STATE OF CONNECTICUT
CONNECTICUT SITING COUNCIL

IN RE: :
 :
APPLICATION OF CELLCO : DOCKET NO. 469
PARTNERSHIP D/B/A VERIZON :
WIRELESS FOR A CERTIFICATE OF :
ENVIRONMENTAL COMPATIBILITY AND :
PUBLIC NEED FOR THE CONSTRUCTION, :
MAINTENANCE AND OPERATION OF A :
WIRELESS TELECOMMUNICATIONS :
FACILITY AT 520 BAILEY HILL ROAD IN :
KILLINGLY, CONNECTICUT : SEPTEMBER 21, 2016

**RESPONSES OF CELLCO PARTNERSHIP D/B/A VERIZON WIRELESS
TO CONNECTICUT SITING COUNCIL PRE-HEARING QUESTIONS, SET ONE**

**Proposed Verizon Wireless 850 MHz Coverage
Killingly, Connecticut and Surrounding Area
(*Map Scale is 1:30,000)**

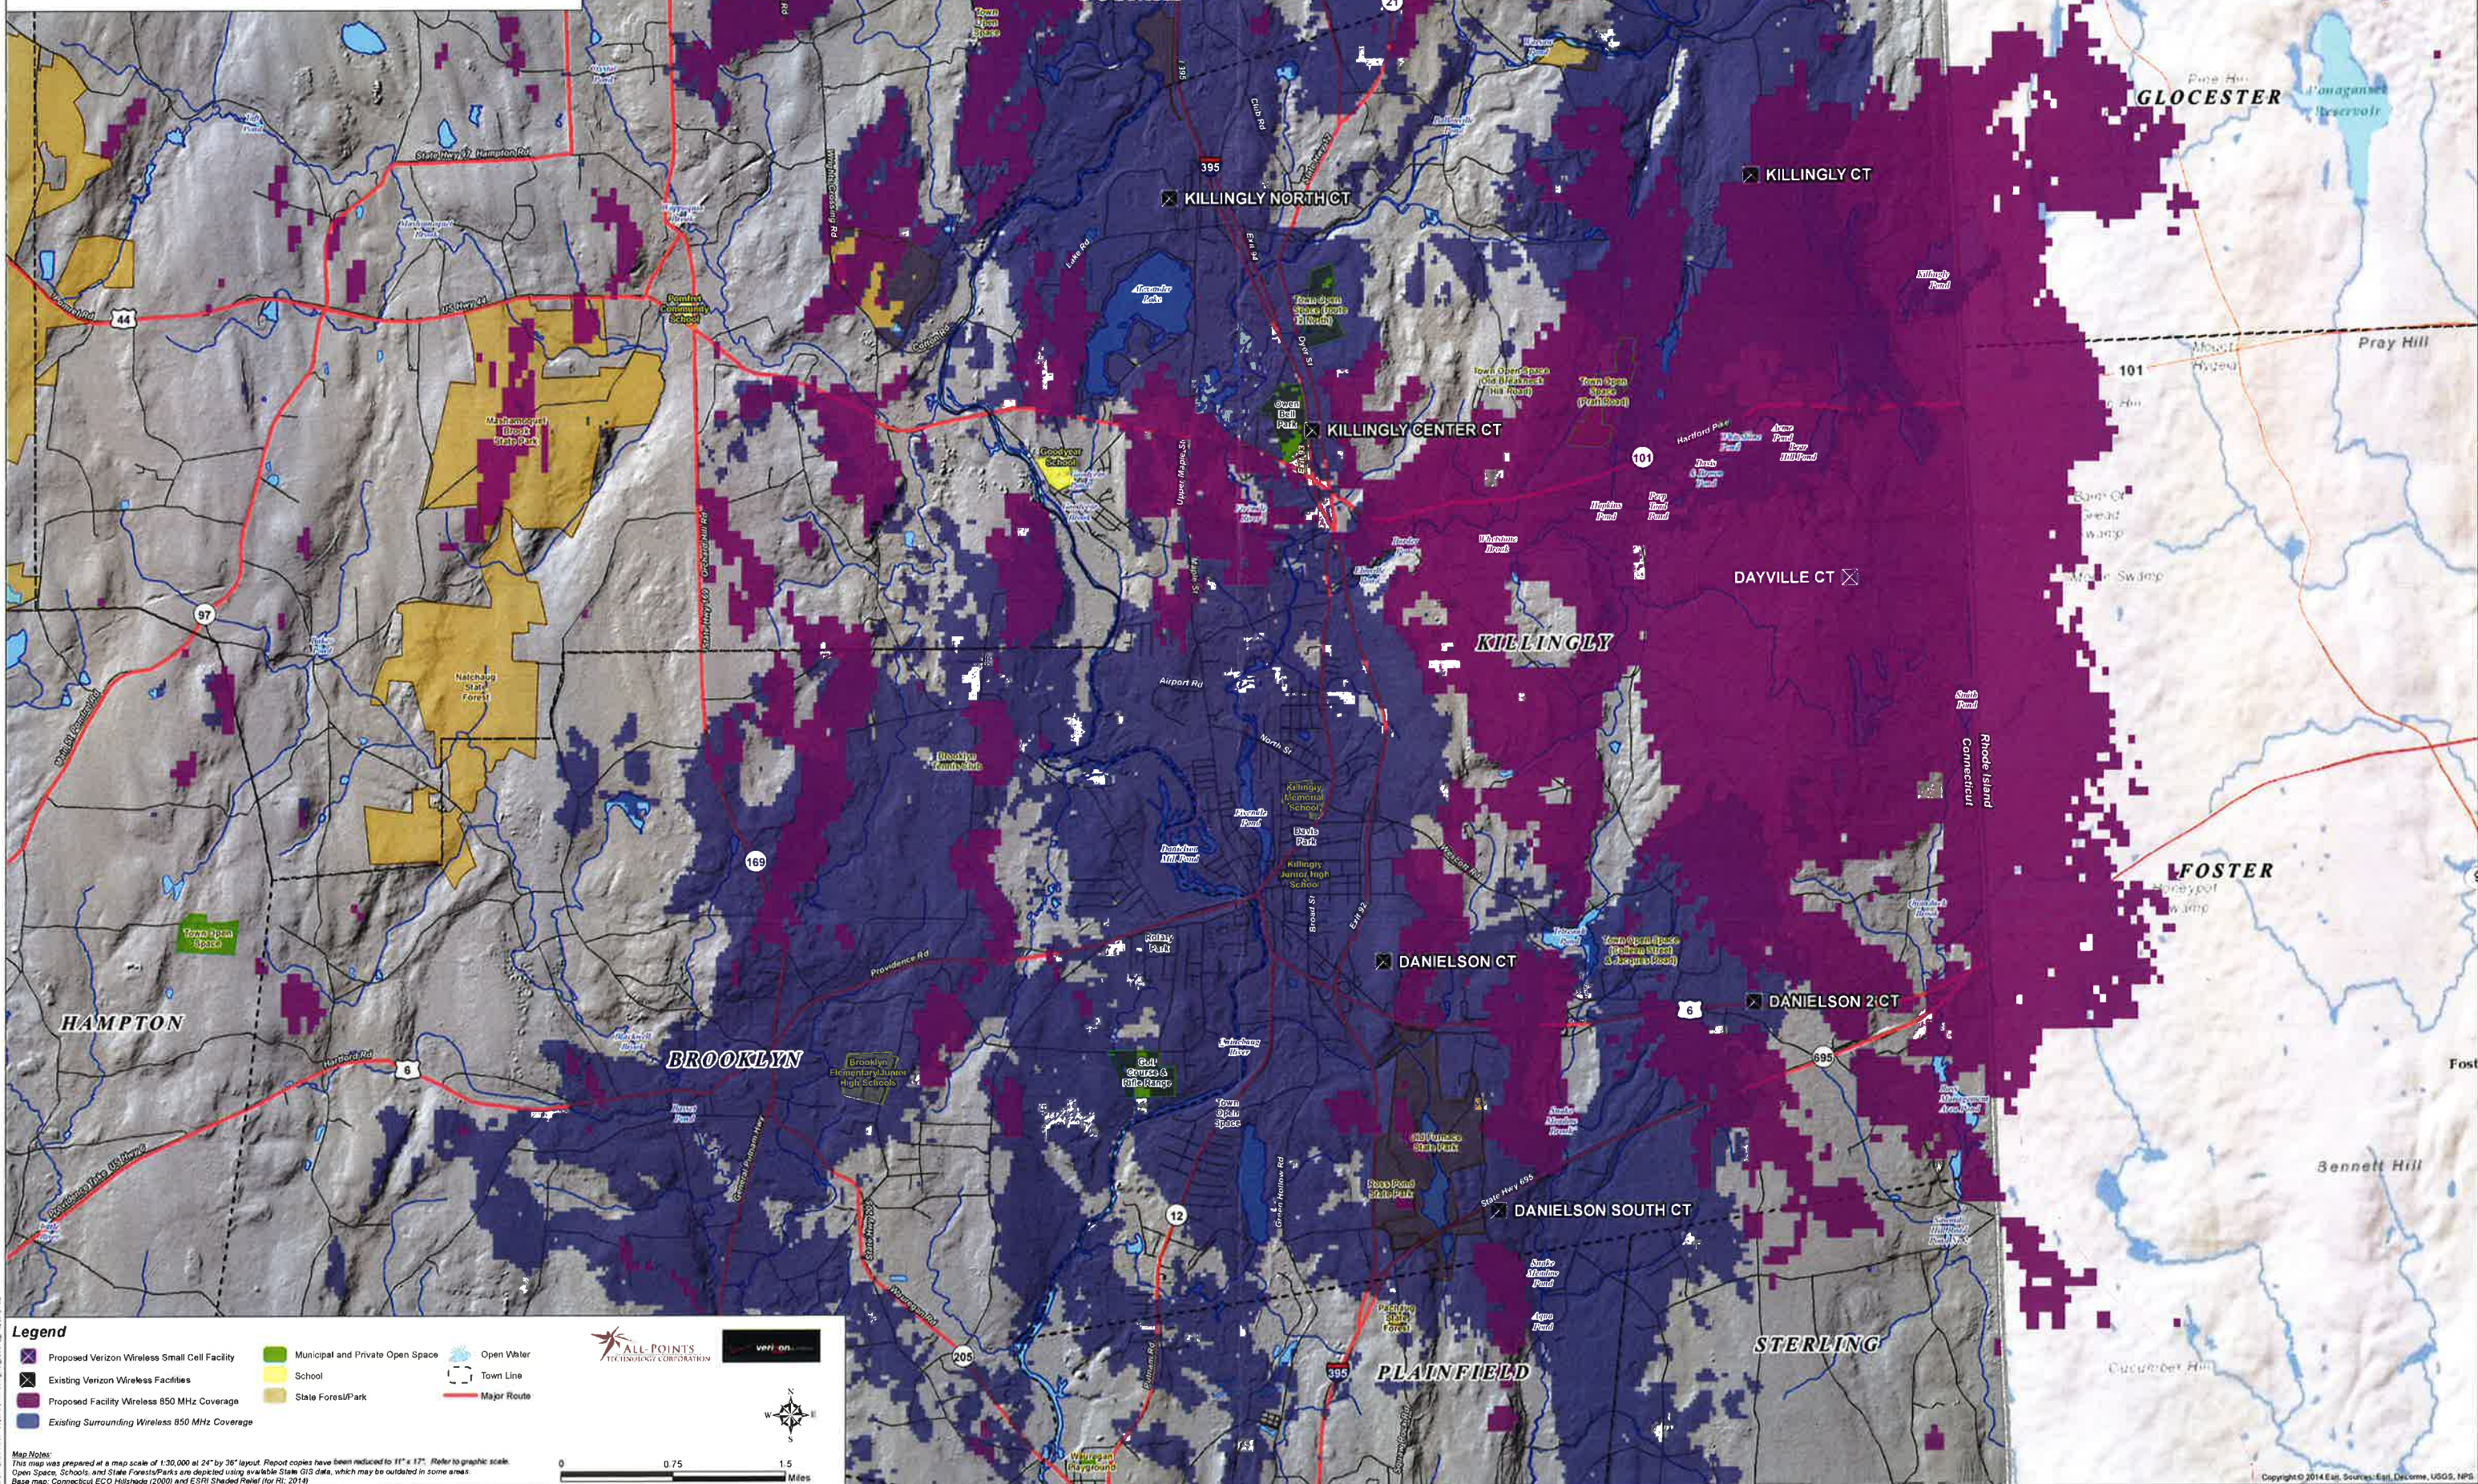
In the Application, Cellco submitted existing propagation maps for all four frequency bands and proposed propagation maps for 700 MHz, 1900 MHz, and 2100 MHz. Provide the proposed propagation map for 850 MHz.

A copy of the propagation map requested is included in Attachment 1.

**Proposed Verizon Wireless 700 MHz Coverage
With An Antenna Centerline Height of 140 Feet AGL
Killingly, Connecticut and Surrounding Area
(*Map Scale is 1:30,000)**

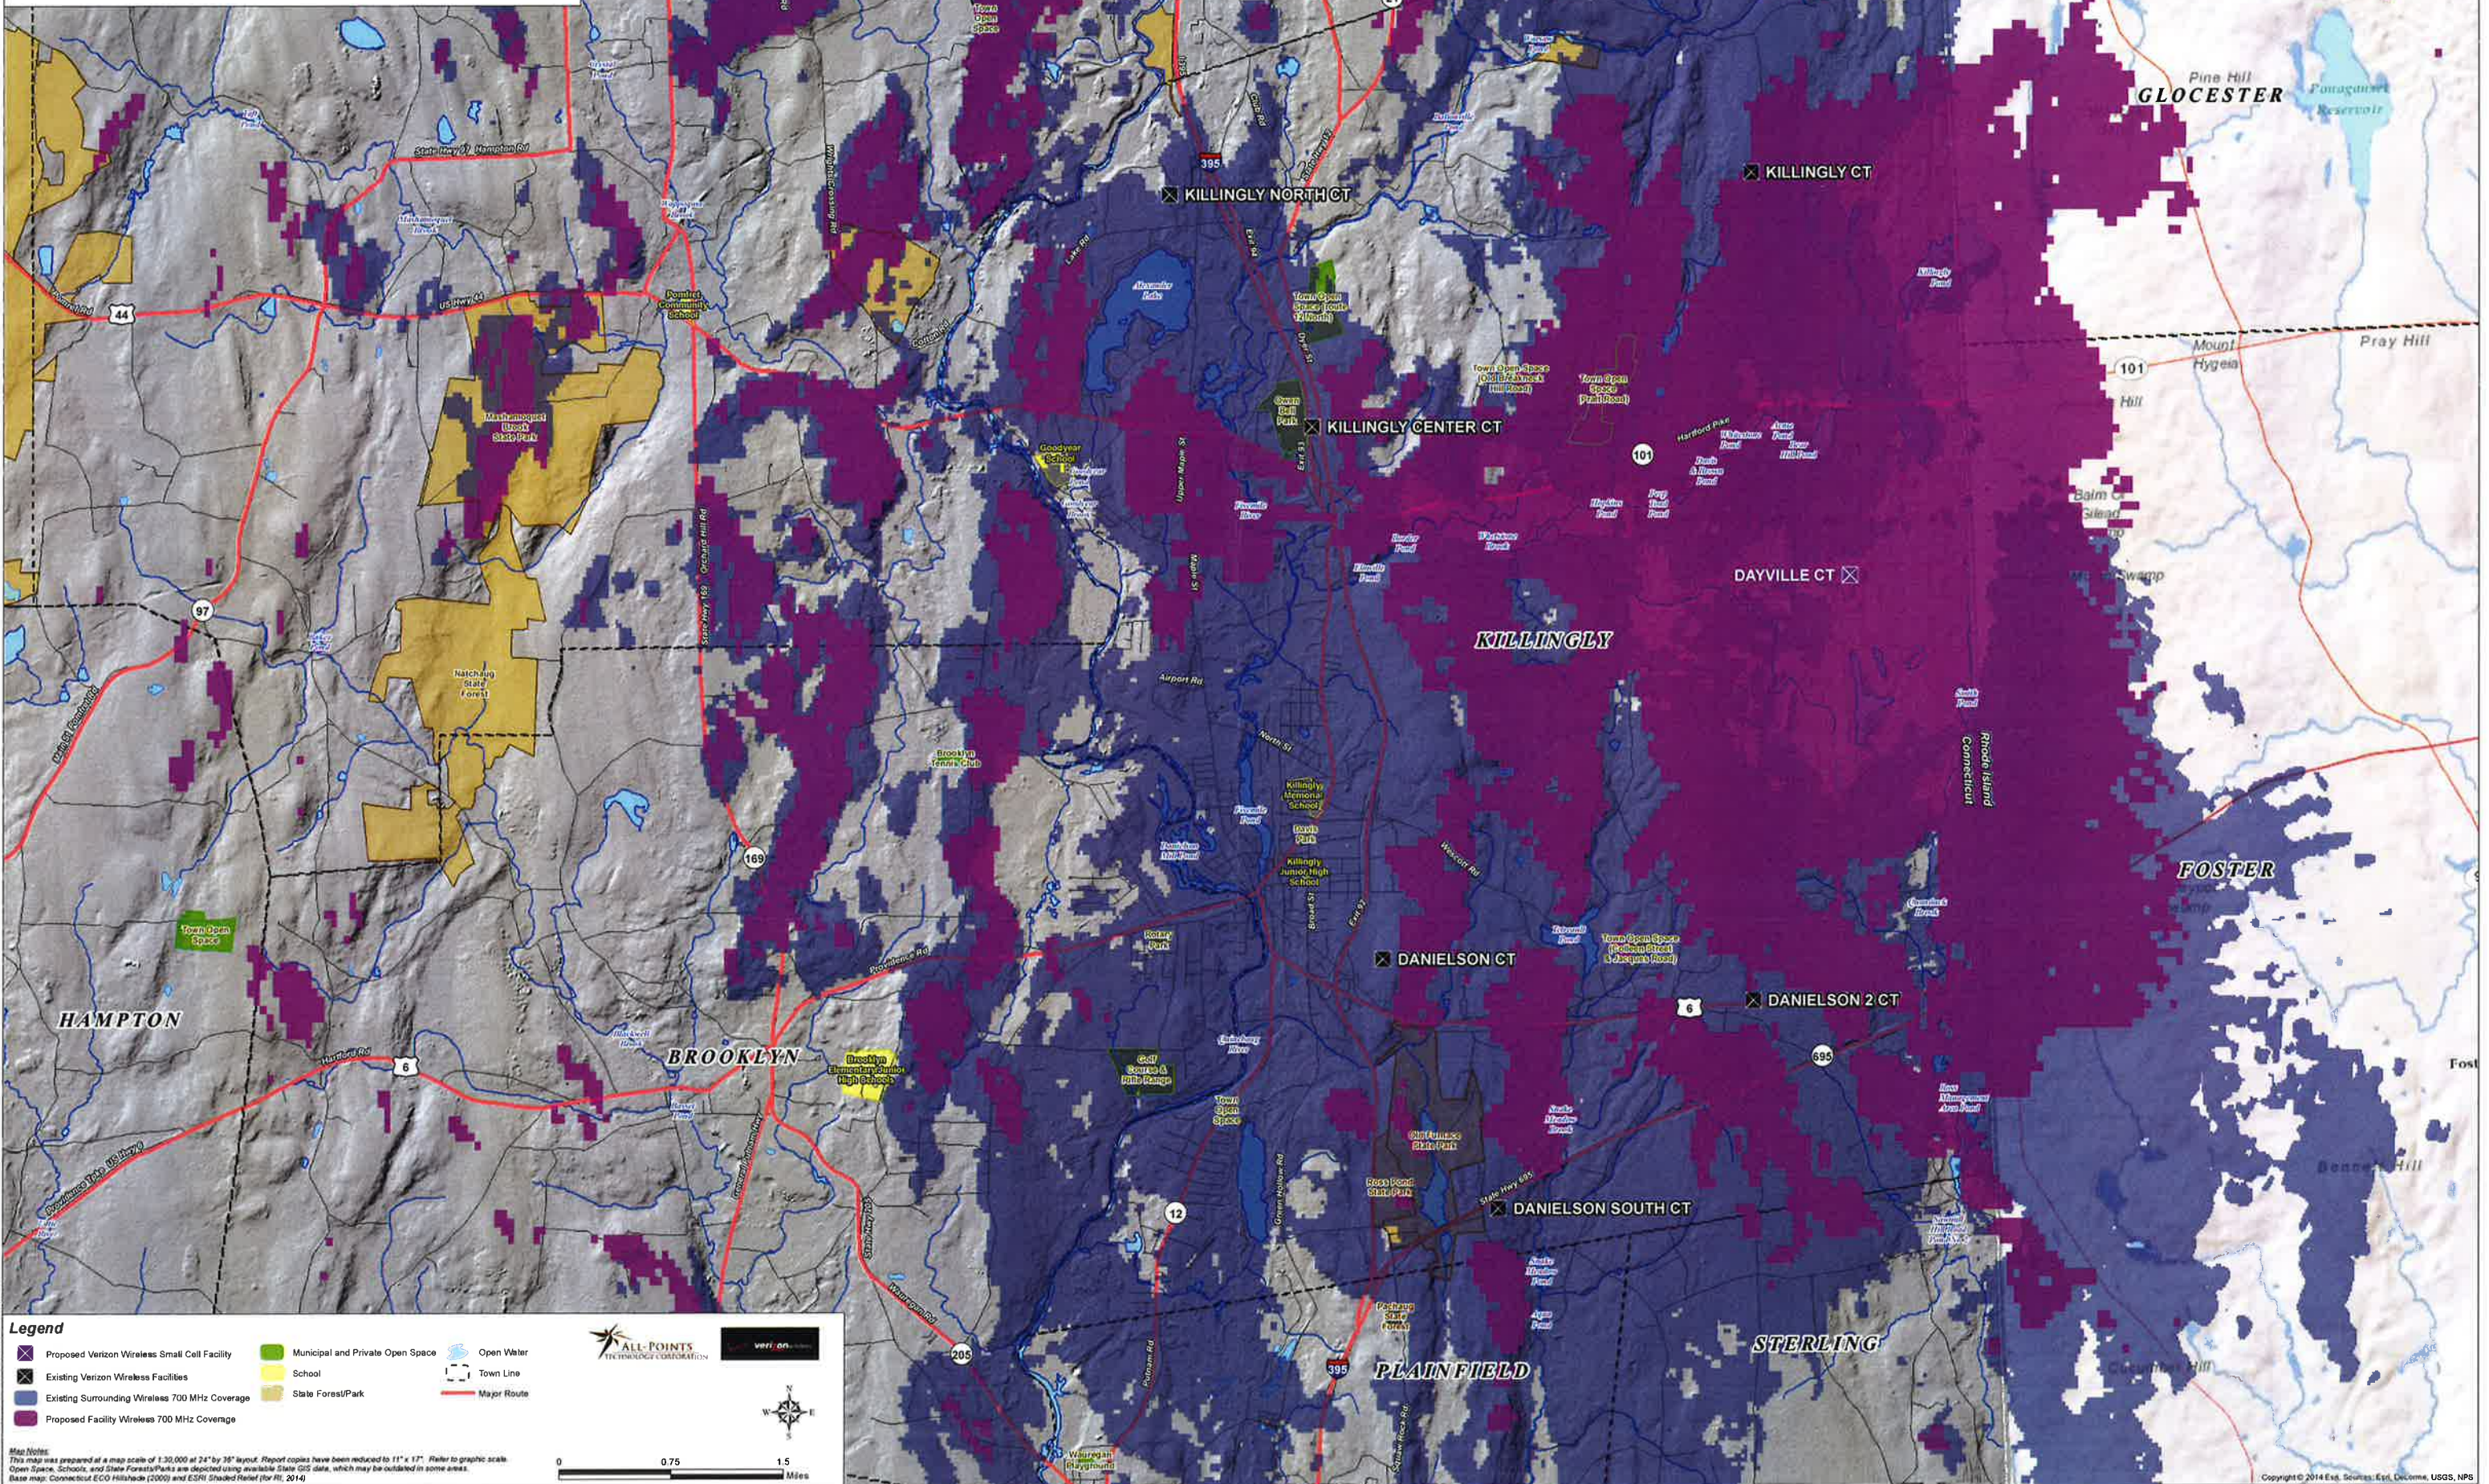
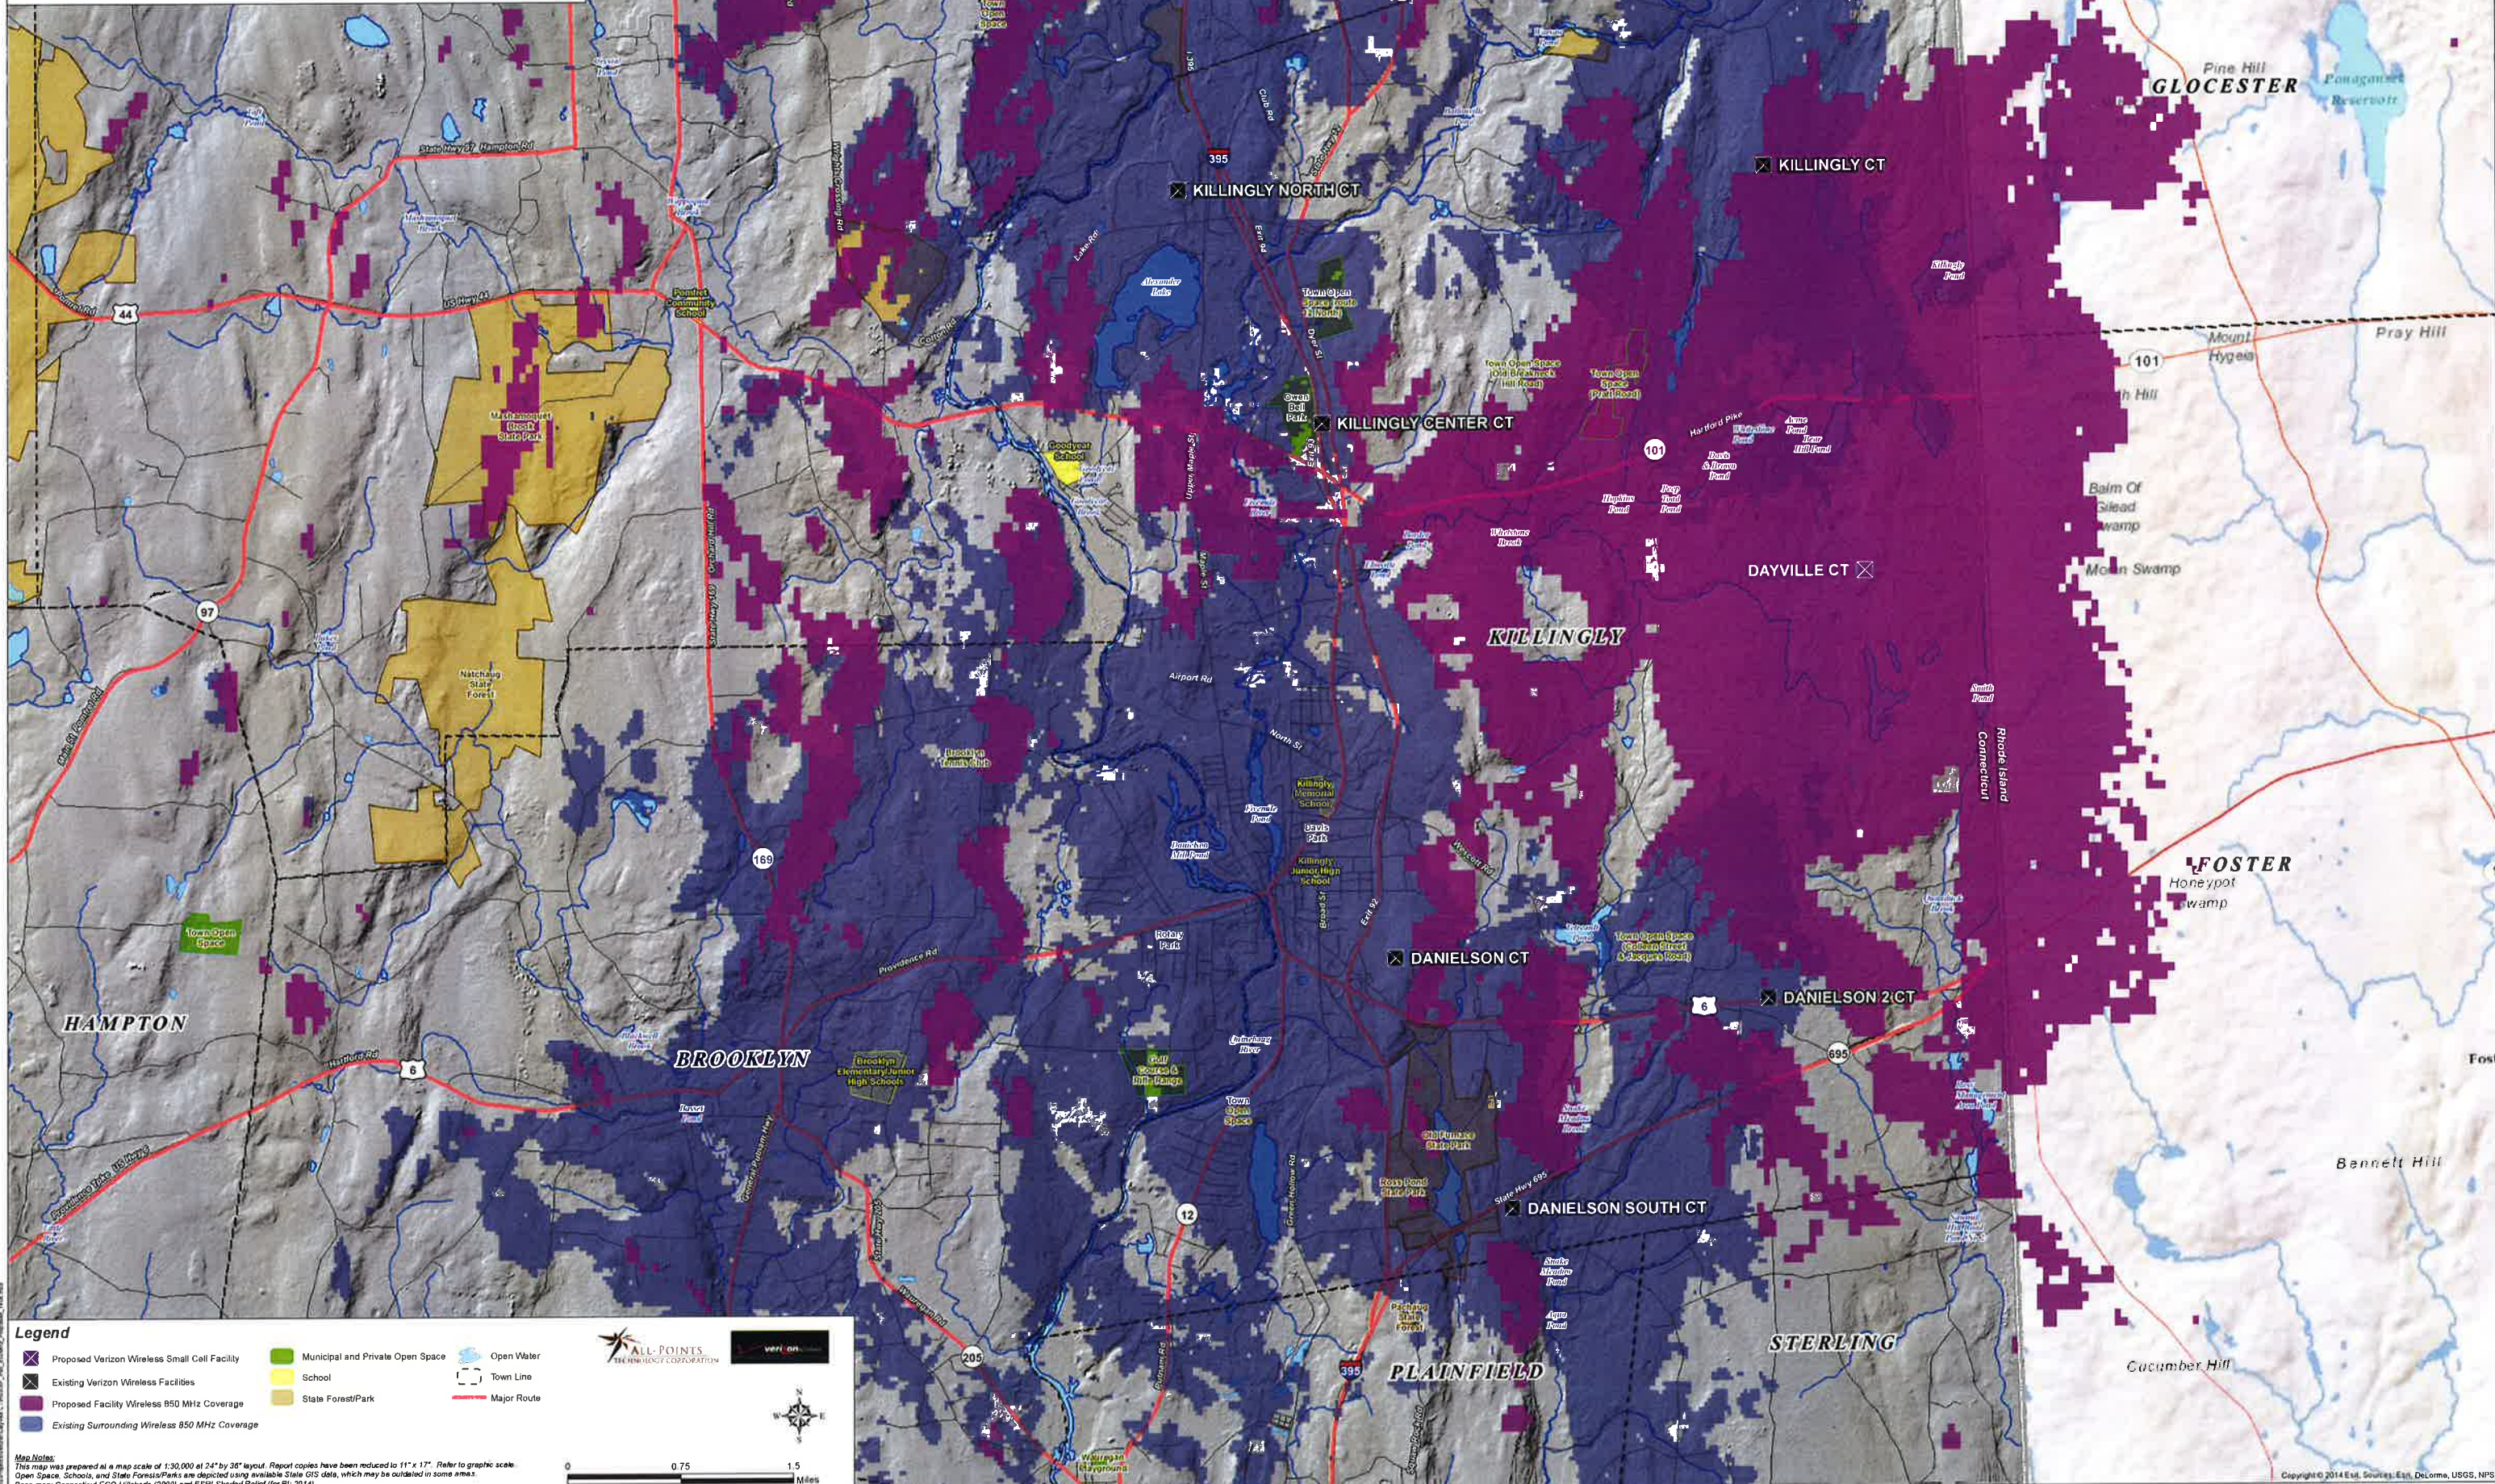
Similar to the proposed propagation maps, submit propagation maps for all four frequency bands (i.e. 700 MHz, 850 MHz, 1900 MHz, and 2100 MHz) assuming that the tower

is ten feet shorter than proposed (i.e. antennas are installed at a centerline height of 140 feet above ground level).

The propagation maps requested are included in Attachment 2.
